ATTACHMENT 1
REVISED TS PAGES

8409170403 840907
PDR ADDCK 05000261
P PDR

ATTACHMENT 2
REPLACEMENT TS PAGES

REPLACEMENT INSTRUCTIONS

Figure 2.1-1

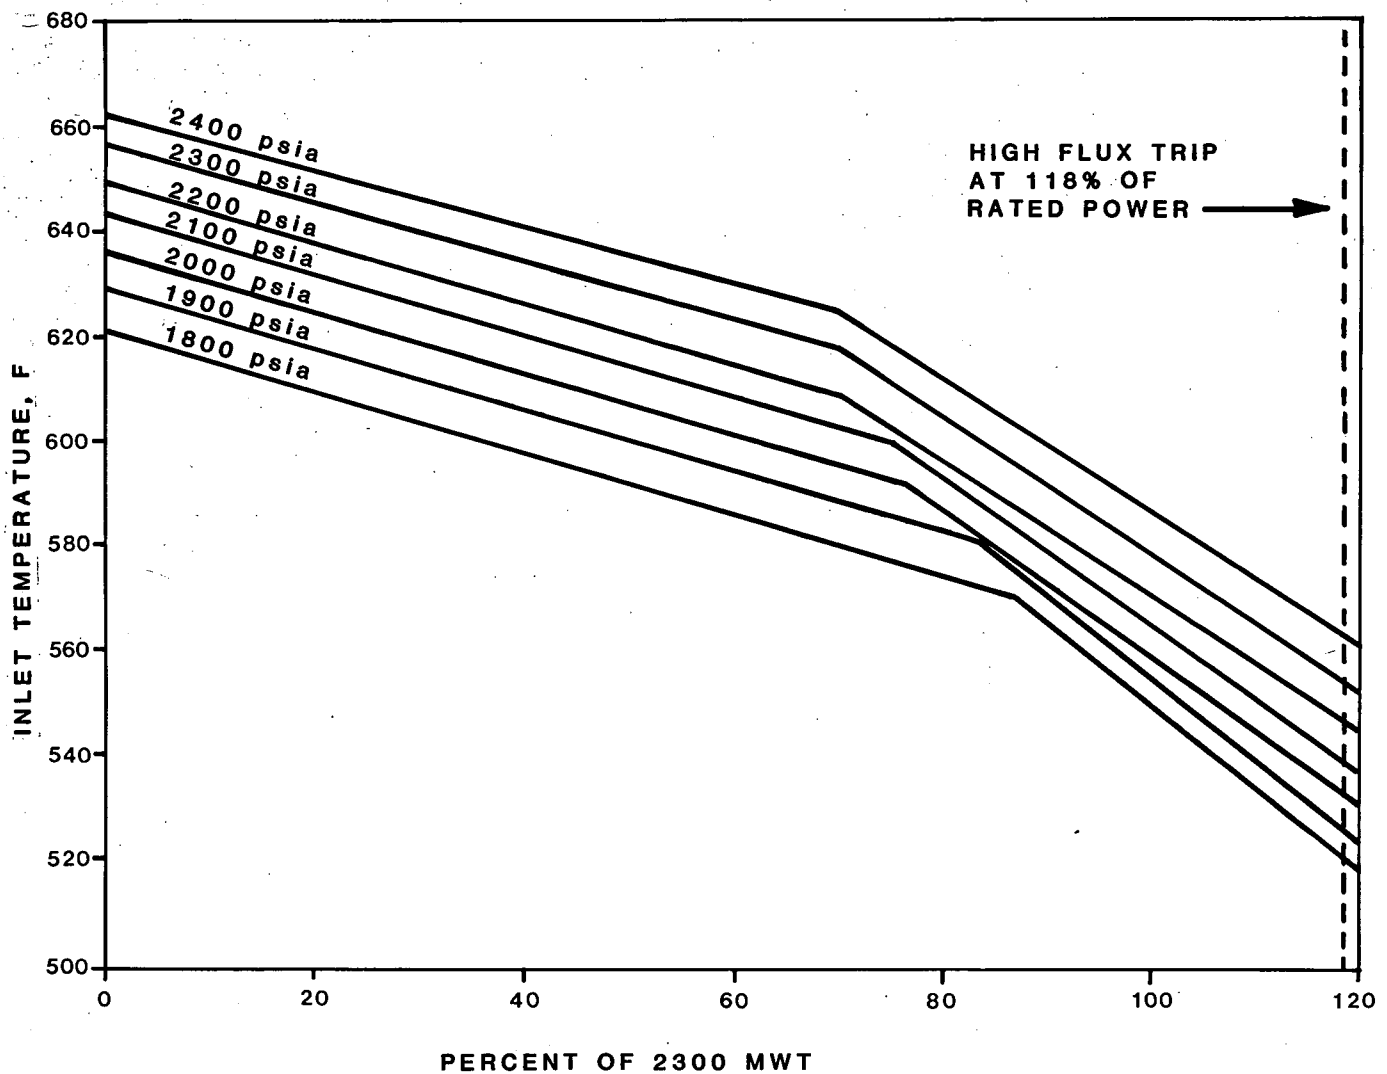
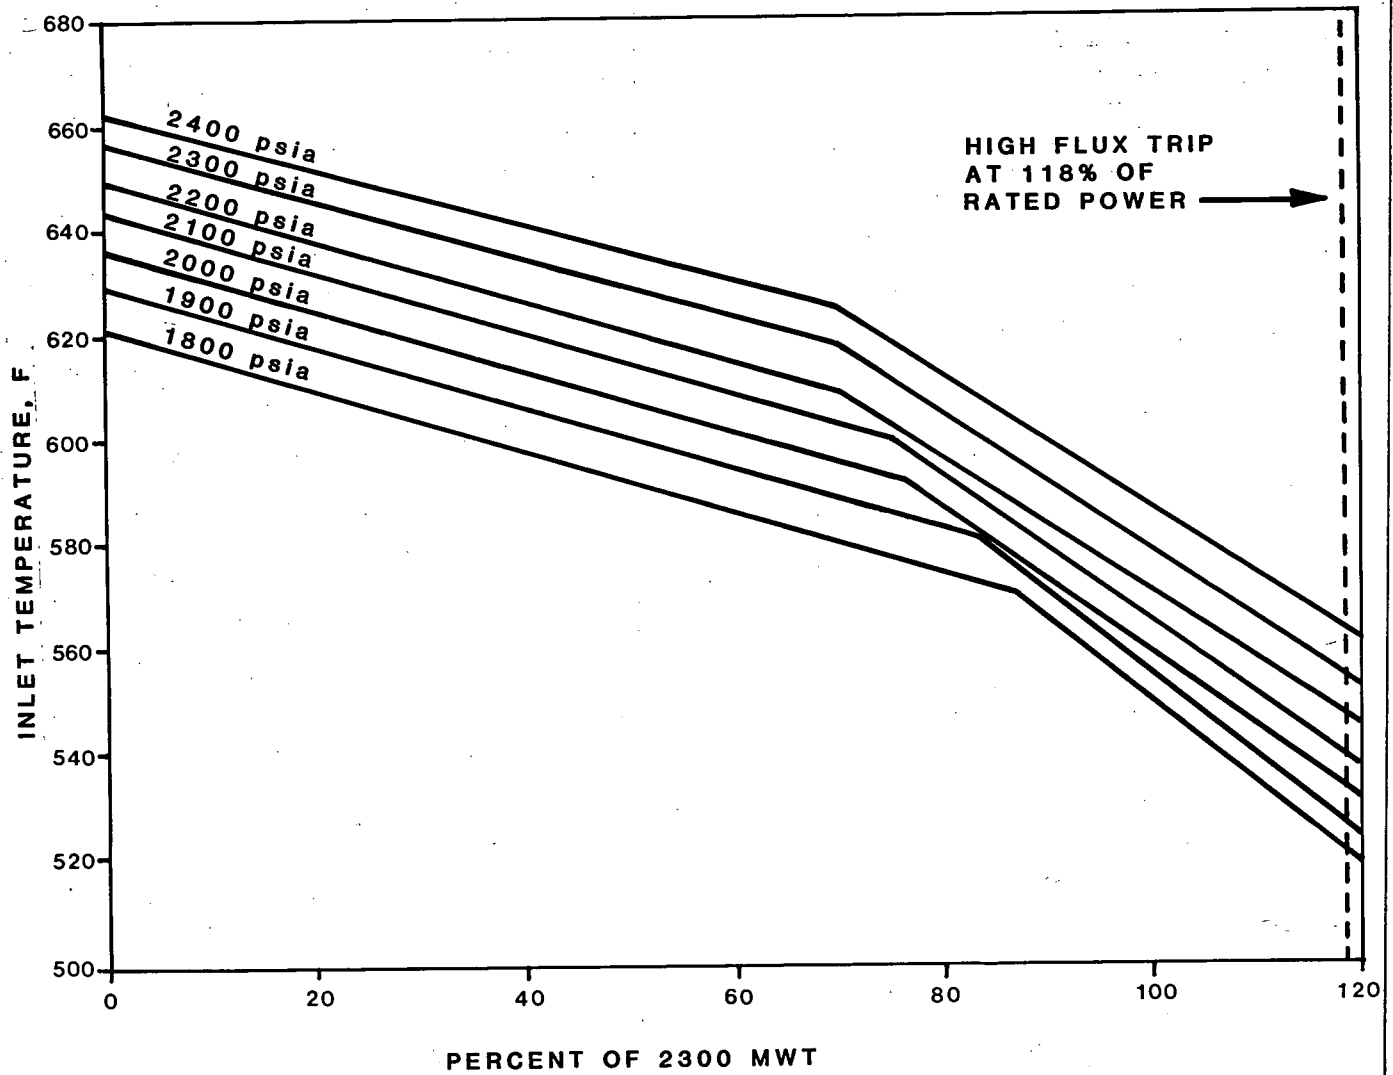
- a. The combination of thermal power level, coolant pressure, and coolant temperature shall not exceed the limits shown in Figure 2.1-1 when full flow from three reactor coolant pumps exists.

- d. The safety limit is exceeded if the combination of Reactor Vessel inlet temperature and thermal power level is at any time above the appropriate pressure line in Figure 2.1-1 or if the thermal power level, coolant pressure, or Reactor Vessel inlet temperature violates the limits specified above.

The curves of Figure 2.1-1 which show the allowable power level decreasing with increasing temperature at selected pressures for constant flow (three loop operation) represent the loci of points of thermal power, reactor vessel inlet temperature, and coolant system pressure for which the DNB ratio is not less than 1.17. The area where clad integrity is assured is below these lines. The temperature limits at low power are considerably more conservative than would be required if they were based upon a minimum DNB ratio of 1.17 but

are set to preclude bulk boiling at the vessel exit. An arbitrary upper safety limit of 118% thermal power is shown. This limit is based on the high flux trip including all uncertainties.

Radial power peaking factors consistent with the limit on $F_{\Delta H}$ given in Specification 3.10.2.1 have been employed in the generation of the curves in Figure 2.1-1. An additional heat flux factor of 1.03 has been included to account for fuel manufacturing tolerances and in-reactor densification of the fuel.

The safety limit curves given in Figure 2.1-1 are for constant flow conditions. These curves would not be applicable in the case of a loss of flow transient. The evaluation of such an event would be based upon the analysis presented in Section 15.3 of the FSAR.
